APP/R3650/W/25/3367393 and APP/R3650/W/25/3366387 – WAVERLEY BOROUGH COUNCIL STATEMENT RELATING TO APPELLANTS FLOOD RISK, LANDSCAPE AND ECOLOGY EVIDENCE – 13 FEBRUARY 2026

WAVERLEY BOROUGH COUNCIL: LAND NORTH OF LYDIA PARK, STOVOLDS HILL, CRANLEIGH
SUPPLEMENTARY LANDSCAPE NOTE

FIGURE 7 – PROPOSED SURFACE WATER MITIGATION STRATEGY (CONCEPT PLAN)

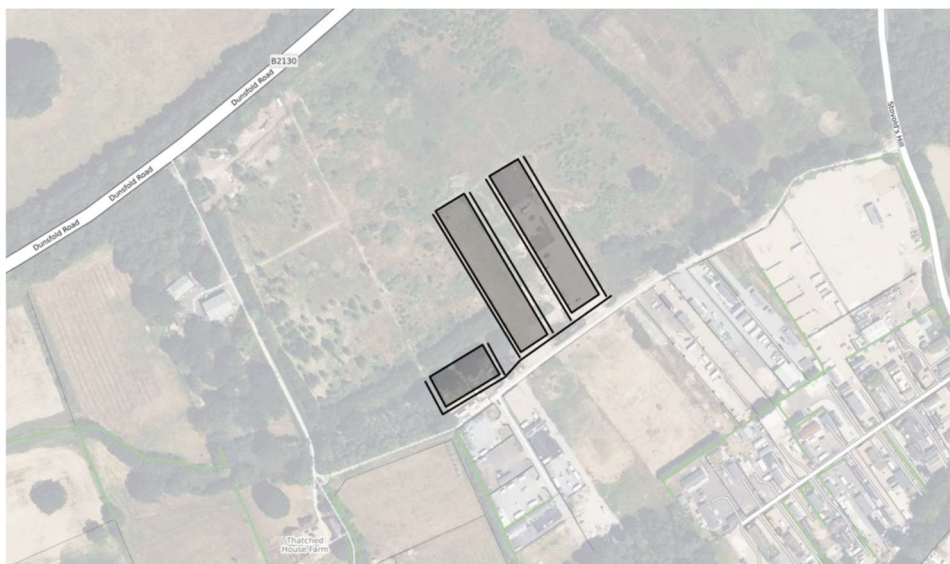
22. This introduces a third feature in the form of a number of additional drainage channels shown diagrammatically in Figure 7.

The FRA is based on these works having been undertaken.

23. Few details are provided but the modelling undertaken and illustrated in Figure 16 seems to be predicated on these works being carried out. Such works are outside the application site.

24. Both the proposed new ditch and culvert under the access track would be significant engineering operations which are not included in the description of development and have not been identified until now, 11 months after the application was submitted, and 8 months after the appeal. Equally, the proposed off-site ditches are new works that are not part of the application or included within the site area.
